Transitional Programme – Botanic Garden ki Paekākā to city accessibility audit

Project Name	Accessibility Audit, Wellington City Transitional Programme, Botanic Garden ki Paekākā to City Bike and Bus Improvements
Status	Draft report
Client	Wellington City Council
Client Reference	
MRC Reference	NZ3201
File Name	O:\NZ_Root\01. Projects\NZ3201 Wellington Cycleways Accessibility Audits\2. Issued\Accessibility Audit - Botanical gardens to city_Draft 211130.docx

Figure 3 Botanical Gardens access road entrance opposite Kilmister Avenue⁵

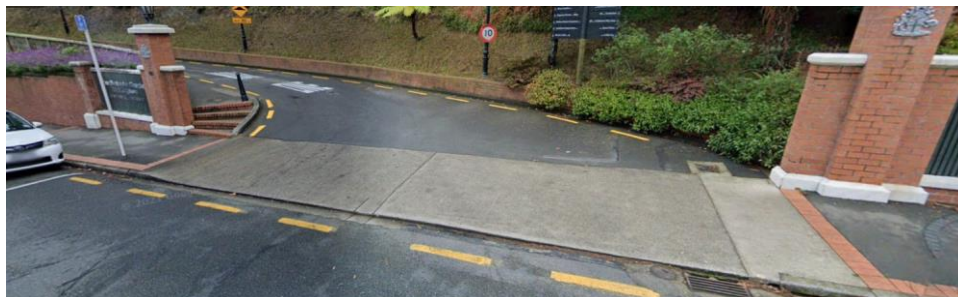
Right of way should be established at the Botanic Gardens entrance. It is unclear whether this is a private accessway or public road. TGSIs are recommended on both footpath approaches.

Botanical gardens accessway	
Access principle(s):	Safe / Obvious
Overall Rating	Major
Designer response	Botanic Gardens Centennial entrance is a driveway and therefore does not warrant tactile pavers
Safety Engineer	Agree with Designer. However, traffic volumes on the driveway should be checked. If significant the need for tactiles should be revisited.
Action taken	No action required.

Figure 6 Excerpt from plan - Bowen Street - proposed pedestrian refuge (C14)

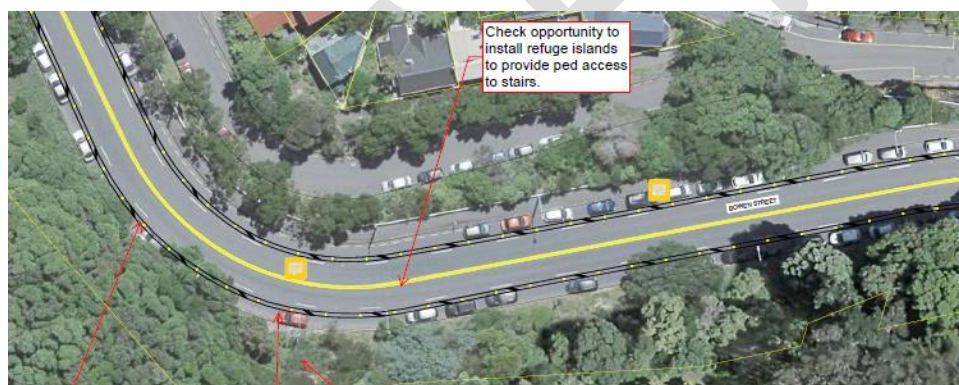
The design includes a new pedestrian refuge approximately 180 metres east of the Tinakori / Bowen Street intersection. The proposed refuge is on a bend to provide access to steps to the Botanic Gardens. Consideration should be given towards ensuring the refuge is safe with appropriate visibility maintained on both approaches within a suitably low speed environment. The crossing in its current design is unlikely to feel safe for all pedestrians.

Proposed pedestrian refuge	
Access principle(s):	Safe / Obvious / Step free
Overall Rating	Major
Designer response	Unable to install pedestrian refuge due to vehicle tracking and sightlines around the corner
Safety Engineer	Agree with Designer. This issue is currently under review by Transport and Infrastructure outside of the Cycleway Programme.

Proposed pedestrian refuge	
Action taken	Out of scope of project. LGWM to investigate

Figure 8 Excerpt from plan - Bowen Street / The Terrace intersection (C16)

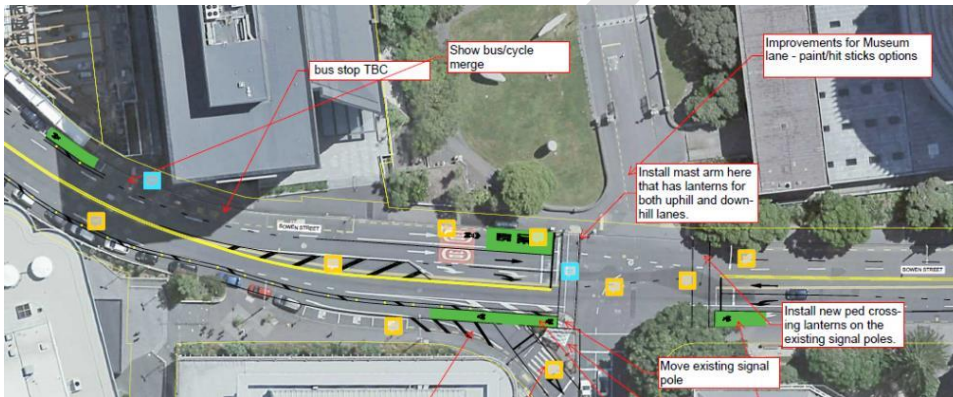
The eastbound cycle lane approach to The Terrace proposes to merge with the bus lane due to vehicle capacity issues and carriageway width constraints. Cyclists may not feel safe merging and may choose to avoid conflict with buses and use the adjacent footpath to safely navigate past this intersection. It is recommended to reconsider the proposed design of merging cyclists with buses.

It is unclear whether advanced cycle boxes will be retained for right turning cyclists on the Bowen Street eastbound approach.

Bus Lane / Cycle Lane Merge	
Access principle(s):	Safe / Obvious
Overall Rating	Major
Designer response	Is not enough space of separate cycleway in this location whilst also providing public transport priority. Speed difference between cyclists and traffic in this location is minimal
Safety Engineer	Agree with Designer. Issue to be monitored and addressed as necessary.
Action taken	Monitor and pass to LGWM to investigate.

Figure 9 Excerpt from plan - Bowen Street / Lambton Quay intersection (C17)

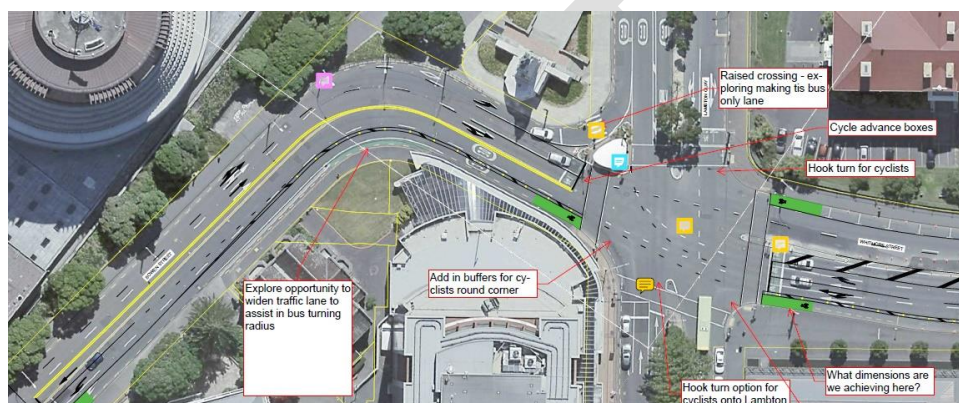
It is unclear whether the cycle lane is re-established along Bowen Street between The Terrace and Lambton Quay or if cyclists continue to share a lane with buses. If the cyclists are continuing to share a traffic lane with buses, this may not be obvious to cyclists, and they may not feel safe using this lane therefore choosing to use the footpath adjacent. It is recommended that it is made clear to cyclists where they are intended to cycle, and in doing so, to communicate their likely presence to other road users, particularly bus drivers if they are intended to share the bus lane.

The southbound cycle lane on Whitmore Street does not appear to be separated from traffic lanes. Cycle lanes that are not physically separated (through delineators) from other traffic can feel unsafe to cyclists where they may choose not to use them and use the footpath instead.

Bowen Street cycle lane	
Access principle(s):	Safe / Obvious
Overall Rating	Major
Designer response	Cycleway commences at Whitmore St and cyclists on Bowen St share the lane. Is not enough space on Bowen St for separate cycleway in both directions
Safety Engineer	Agree with Designer. Issue to be monitored and addressed as necessary.
Action taken	Monitor and pass to LGWM to investigate.

Figure 10 Excerpt from plan - Whitmore Street / Stout Street intersection (C18)

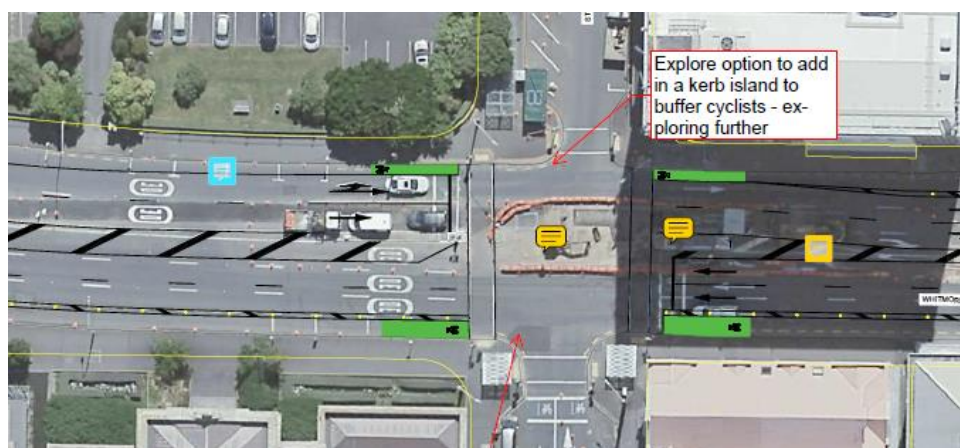
Confirm that the southbound cycle lane on approach and exit meets minimum width standards to ensure it is safe for cyclists to use. There also does not appear to be physical separation (delineators) between the cycle lane and traffic lane which may deter cyclists from using the cycle lane.

Cycle lane at Stout Street	
Access principle(s):	Safe
Overall Rating	Major
Designer response	Cycleway width of 1.2m in this location has been used to avoid impacting on central islands. WCC to investigate whether central islands can be moved or removed as part of civil works design.
Safety Engineer	Agree with Designer.
Action taken	Monitor and pass to LGWM to investigate.

Figure 11 Excerpt from plan - Whitmore Street / Featherston Street intersection (C19)

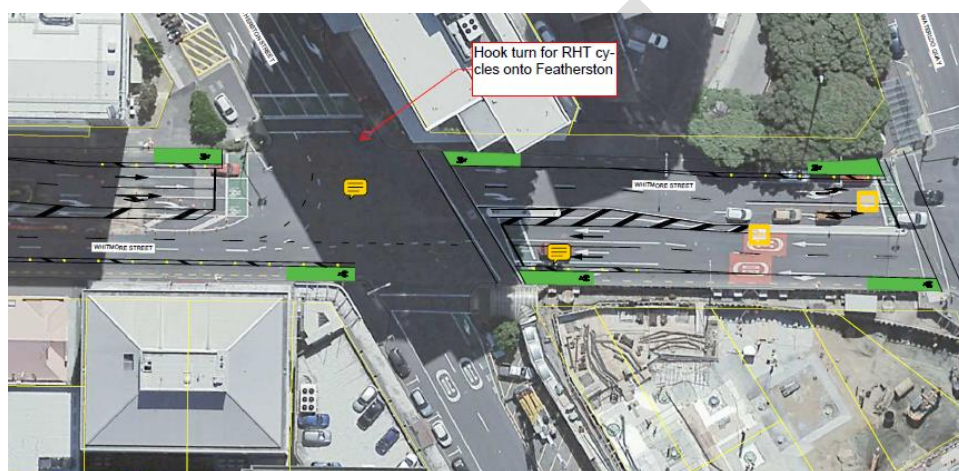
There is potential conflict between vehicles turning left from Whitmore Street into Featherston Street and cyclists heading north through the intersection on Whitmore Street.

There is also a pinch point for cyclists turning left into Featherston St who are not protected from left turning traffic.

Sections of both cycle lanes do not appear to have physical separation from vehicle lanes. It is recommended that delineators are considered to provide protection and improve cyclists' perception of safety.

Cycle lane at Featherston Street	
Access principle(s):	Safe
Overall Rating	Major
Designer response	Cycleway divider will be used in this location which tightens the corner radius for vehicles turning left into Featherston St
Safety Engineer	Agree with Auditors and Designer.
Action taken	Designs updated.

Figure 12 Excerpt from plan - Whitmore Street / Waterloo Quay intersection (C19)

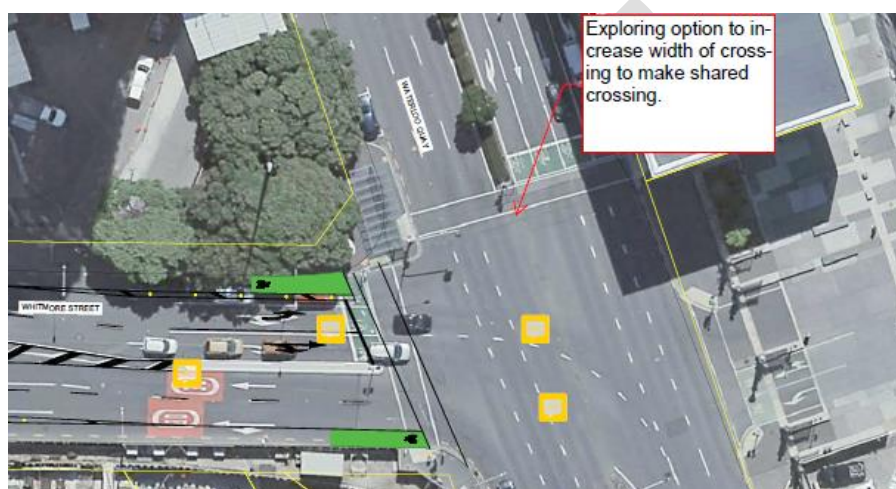
The proposed option to increase the width of the signalised pedestrian crossing across Waterloo Quay should consider allowing pedestrians to cross either west or east of Whitmore Street.

It is not clear whether the design includes signage or prompts to inform cyclists (make it obvious) that the cycle lane has ended. It is recommended that wayfinding for cyclists at the end of the route be considered.

Pedestrian / cycle crossing at Waterloo Quay	
Access principle(s):	Safe / Obvious
Overall Rating	Minor
Designer response	Subsequent design amendments have replaced shared pedestrian/ cyclist crossing with an on road cycle crossing
Safety Engineer	Agree with Designer on design amendments. However, the feasibility of a pedestrian crossing east of Whitmore should be checked outside of the Cycleway Programme. It may be that the signal design is at its limits and pedestrians cannot be accommodated on that leg.
Action taken	Designs update.

Wayfinding at Waterloo Quay	
Access principle(s):	Safe / Obvious
Overall Rating	Comment
Designer response	Wayfinding signage to be provided with cycleway implementation
Safety Engineer	Agree with Auditors and Designer.
Action taken	Investigate wayfinding signage.
